CLEVELAND NATIONAL FOREST POWER LINE REPLACEMENT PROJECTS

MINOR PROJECT REFINEMENT REQUEST FORM

Date Submitted:	08-25-20 (Revised 10-15-20)	Request #:	048
Date Approval Required:	10-21-20	Landowner:	XXX
APN:	XXX-XXX-XX		
Refinement from (check all that apply):			
<input type="checkbox"/> Mitigation Measure	<input type="checkbox"/> APM	<input checked="" type="checkbox"/> Project Description	<input type="checkbox"/> Drawing
Identify source (mitigation measure, project description, etc.):			
<p>Notice to Proceed request #25 for Transmission Line (TL) 626 Conversion North and TL626RFS of the Cleveland National Forest Power Line Replacement Projects (Project) was approved by the California Public Utilities Commission (CPUC) on February 4, 2020 and by the United States Forest Service (USFS) on February 5, 2020. Due to the discovery of sensitive cultural resources during construction on TL626 Conversion North at the approved replacement pole location for Pole P259378 (Location 72) on March 13, 2020, the replacement pole location needs to be shifted to avoid these sensitive resources. This Minor Project Refinement (MPR) request integrates design considerations, such as the re-design of P

ATTACHMENT B: COMPARISON MAP

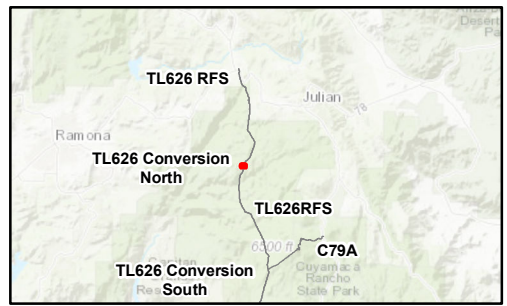
(d) Does the proposed refinement trigger an additional permit requirement?		<input type="checkbox"/> Yes	<input checked="" type="checkbox"/> No	
Describe refinement being requested (attach drawings and photos as needed):				
As depicted in Attachment B: Comparison Map, San Diego Gas & Electric Company (SDG&E) is requesting to shift the replacement pole for Pole P259378 (Location 72) approximately 130 feet south and add a temporary pole work area at this location. Vegetation removal will be required for use of the refinement area. The requested refinement will result in an increase of approximately 0.04 acre of temporary impacts. The new temporary pole work area will be accessed via a footpath. The previously approved temporary pole work area for Pole P259378 will be used to remove the existing wood pole and perform the wire transfer. ² Excluding specialized installation of grounding rods, which is discussed further in the Cultural and Paleontological Resources section, the activities associated with the construction and utilization of the refinement area will occur in the same manner as described in the Final EIR/EIS for construction of the Project.

Provide need for refinement (attach drawings and photos as needed):				
Following the discovery of sensitive cultural resources at Pole P259378 (Location 72) on March 13, 2020, a Notice of Discoveries for this location was sent out by the USFS to the Consulting Parties to the Project's Programmatic Agreement on May 6, 2020. Archaeological monitors from ASM and Native American Monitors were onsite during the discoveries. Following the Notice of Discoveries for this location, the Iipay Nation of Santa Ysabel was designated as the Most Likely Descendent (MLD) by the Kumeyaay Cultural Repatriation Committee. Through consultation with the MLD, it was requested that SDG&E review engineering options to avoid the resources discovered at this location. Details of the consultation process and final pole location can be found in the Confidential Cultural Resources Letter Report (Williams and Roland 2020).
